ADDENDUM NO. 1

RE: Item #2, March 1, 2023 Letting - P 0011(141), NH 0013(146), PCN 06FR, 06WW, Marshall, Spink County - Approach Slab Repair, Polymer Chip Seal & Berm Repair

PLANS: Please destroy sheets 2, 23-35, & 43-56 and replace with the enclosed sheets, dated 2/15/23. Sheet 45A was added. The revisions to sheets 23-35 and sheets 43-56 included adding the Consultant Engineer's Stamp, adding a Polymer Chip Seal to structure 58-101-321, and other miscellaneous revisions. Notable plan revisions are listed here:

DETAIL "Z"
(Plan for Top Steel when drop inlet is used.)

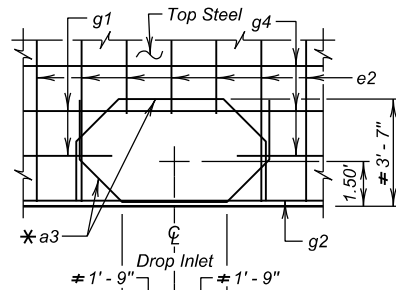
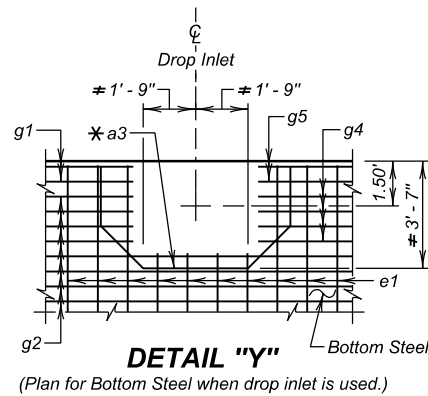
Sheet 31: Added detail Y and a revised detail Z

* Add a3 bar to bottom layer of steel as shown in DETAIL "Y" and top layer of steel as shown in DETAIL "Z".
* Cut all bars in area of drop inlet as shown in DETAIL "Y" and DETAIL "Z".

DETAIL "Y"
(Plan for Bottom Steel when drop inlet is used.)

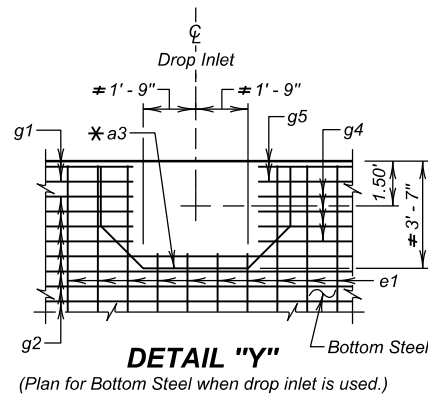
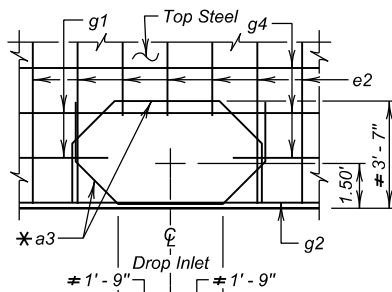
Sheet 49: Added detail Y and a revised detail Z

* Add a3 bar to bottom layer of steel as shown in DETAIL "Y" and top layer of steel as shown in DETAIL "Z".
Cut all bars in area of drop inlet as shown in DETAIL "Y" and DETAIL "Z".
